United States Department of the Interior

Re: R2P2 Minor Modification Request, Skyline Mine, Longwall Panel 6 Left "B", Federal Coal Lease U-044076, Lower O'Connor "A" Seam,

Re: R2P2 Minor Modification Request, Skyline Mine, Longwall Panel 6 Left "B", Federal Coal Lease U-044076, Lower O'Connor "A" Seam,

Figure #1
General Location, 6 Left "B"

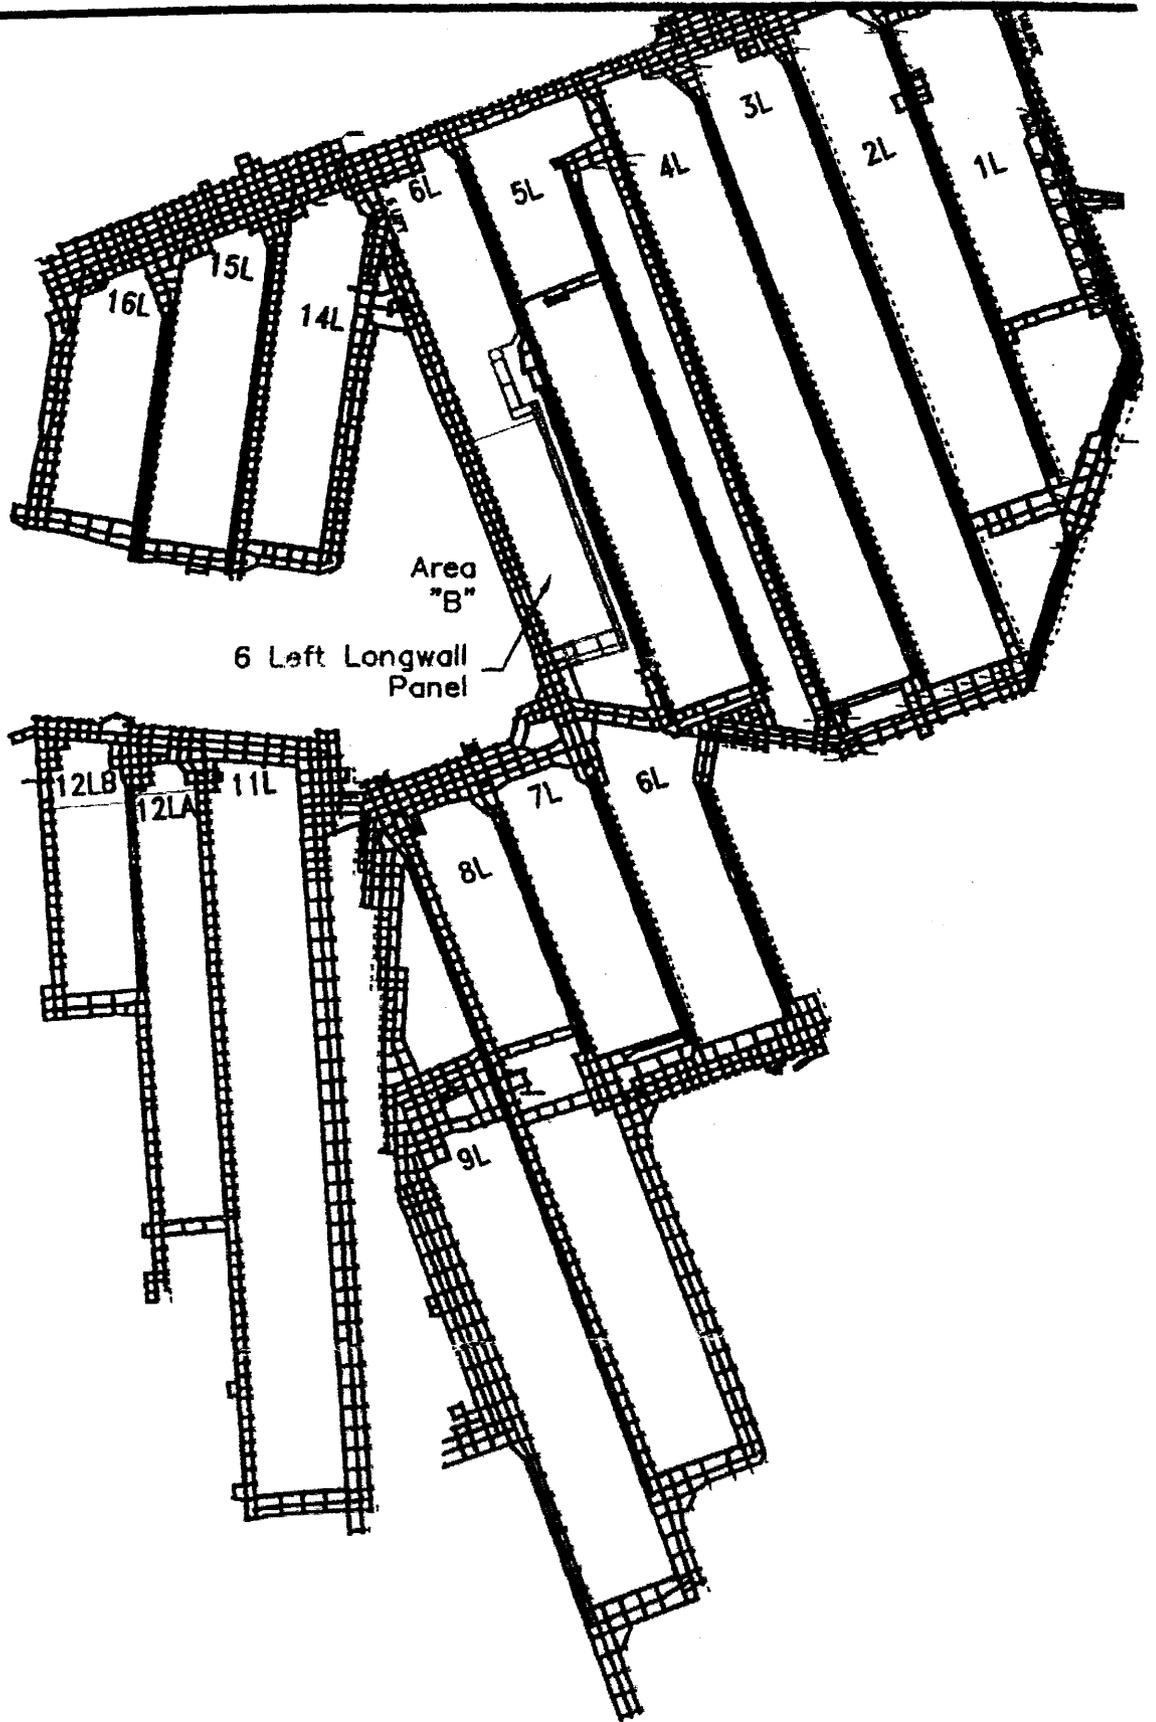
On April 15, 2003, the Bureau of Land Management (BLM) received the written request from Canyon Fuel Company (CFC) concerning the request to modify the approved mining plan (R2P2) for the Skyline Mine. The modification request involves the development of a new tailgate/bleeder (Figure 1), sequencing of the 6 left "B" panel upon completion of the 12 Left "B" panel and the abandonment of the of the longwall equipment upon completion of the panel. They are also requesting the Deletion of Area "B" from the recoverable reserve base.

Approval: BLM approves the development of the new tailgate/bleeders for the 6 Left "B" Panel, extraction of the 6 Left "B" panel upon completion of the 12 Left "B" panel and the elimination of Area "B" from the recoverable reserve base (Figure 2).
